HISTORIC PRESERVATION DESIGN REVIEW

HP-11-15, 43 S. Main St. (City)

The applicant is requesting Historic Preservation Design Review approval for exterior renovations to the building on property located at 43 S. Main St. and represented by Tax Map # 228-13-07-054.

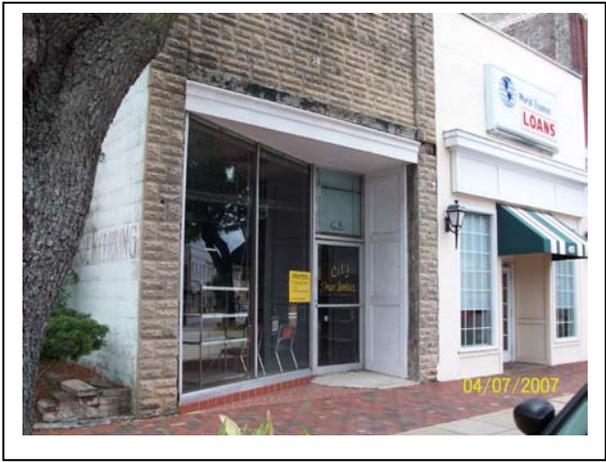
However the main issue is that underneath the stucco were wooden surrounds along the south wall and a constructed wood ceiling and molding along the top of the recessed entrance. When the stucco was removed this wood construction collapsed, leaving large open areas that had to be covered to protect the building from weather and other intrusions.

Staff visited the site on the day of the work and viewed the building, and after consulting with the Building Official a decision was made to allow covering the open areas to protect the building. The applicant did this with simple beaded board ceiling, wooden wall wainscot paneling and architectural molding, primed in white.

The proposed renovations to the storefront area including the wooden molding, paneled wall with wainscoting, and beaded board ceiling are simple, appropriate, and in keeping with the original character and early twentieth century architecture of this building. These are new elements that replace deteriorated areas that were not original to the building and were out of character with its original

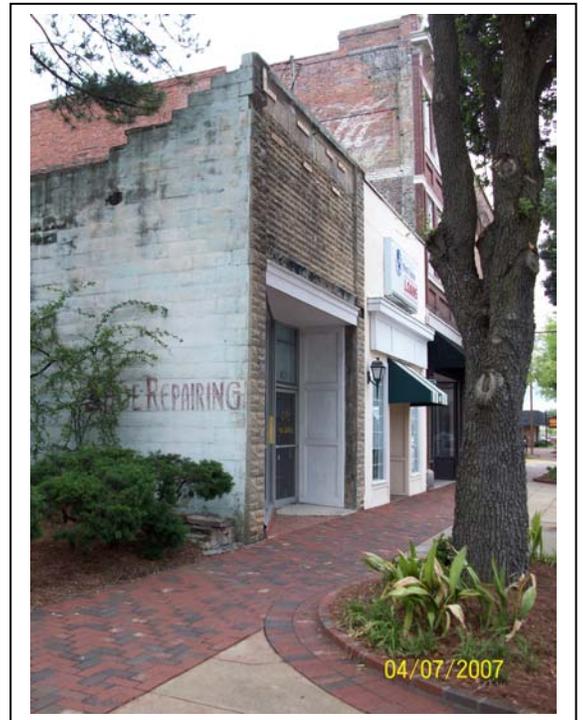
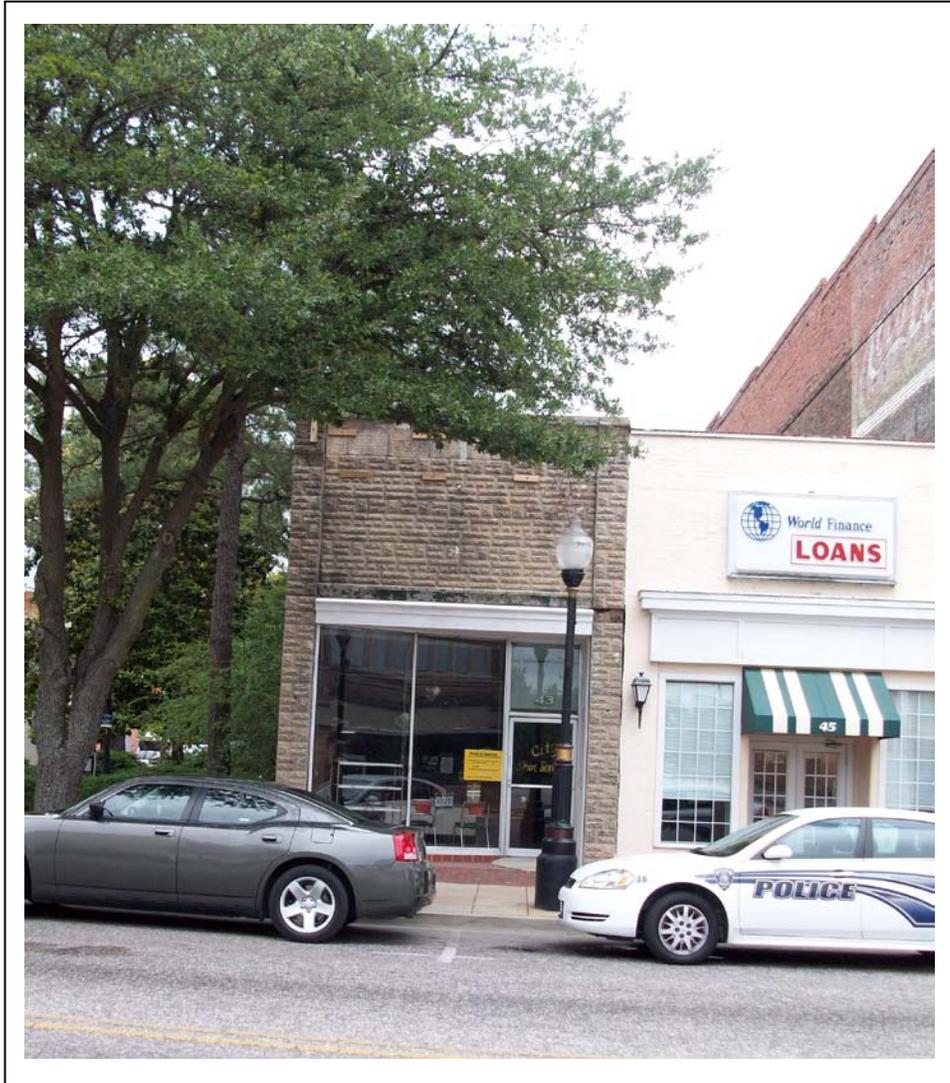
This project involved removal of stucco exterior to reveal the original masonry and decorative frieze work. The applicant will be repairing and stabilizing the original façade and will not paint or otherwise alter or obscure original surfaces.

Restoration of the upper parapet wall with the use of decorative metal turnbuckles and star bolts is appropriate and these elements of historic technology are presently utilized throughout the downtown.

Staff recommends approval of the repairs and renovations to the lower and upper façade as were made in order to stabilize the building, and also recommends approval of the proposed finishing elements as detailed in the staff report. Because the historic fabric of the original street level façade is not able to be determined beyond its location behind the current recessed façade, and because the current aluminum storefront is functional and not planned to be removed, it is in accordance with the guidelines to make repairs and renovations such as were made in the emergency stabilization work, to approve the installed wooden beaded board ceiling, molding, and wainscoting to be painted white, and to allow the temporary bolt and wood block supports along the parapet wall and the second story to be replaced with metal turnbuckles and star-shaped security bolts.
